Doc Name: Chimney 26 Change to Allow for Sequencing of Scaffold Decant

Doc Reference: OTH-PUR-TH-RF-SKE-A-3475

Document Type: Sketch

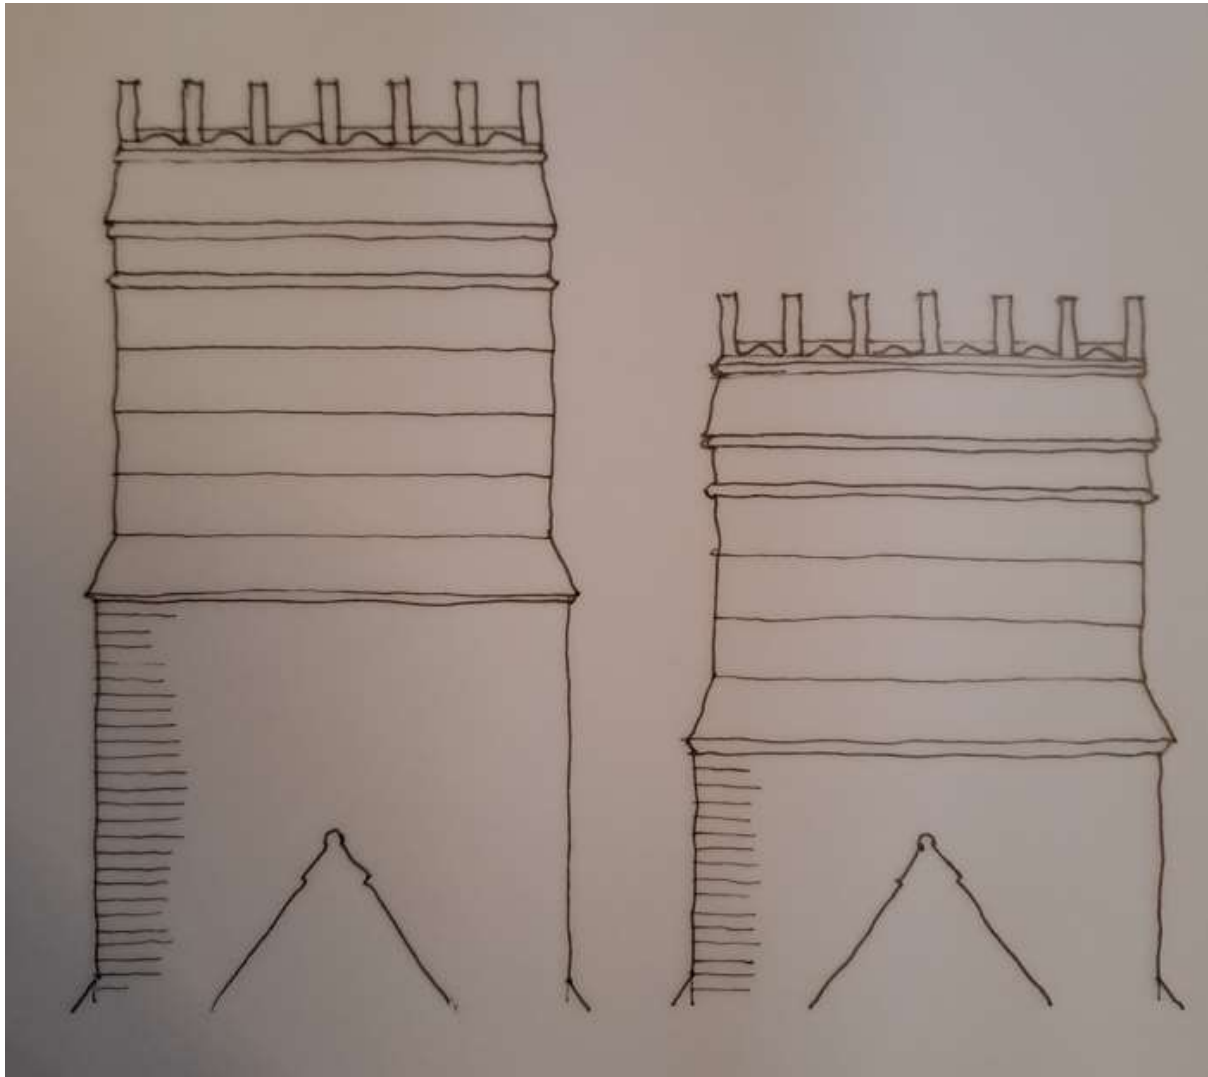
Purpose:	<i>The proposed sequencing of decanting the scaffold for the Great Hall has an inappropriate risk of damage to the Bees Landing rooflight.</i> <i>Alternative sequences have been reviewed. Balancing the procurement, programme and heritage aspects of the project, the preferred solution is to lower the height of the restored chimney (Chimney 26). This allows for localised retention of the scaffolding in its current location whilst the chimney works are carried out.</i> <i>Alteration proposes to lower the height by 10nr courses of brick and 1nr course of ashlar</i>
Location:	Chimney 26
Documents affected:	Chimney details
WP's affected:	Stonework (chimney)
Purcell	Na
Ramboll	Yes
Arup	Na
Planit	Na

Existing Chimney Height

Proposed Chimney Height
(Lowered by 10nr brick courses
and 1nr ashlar course)
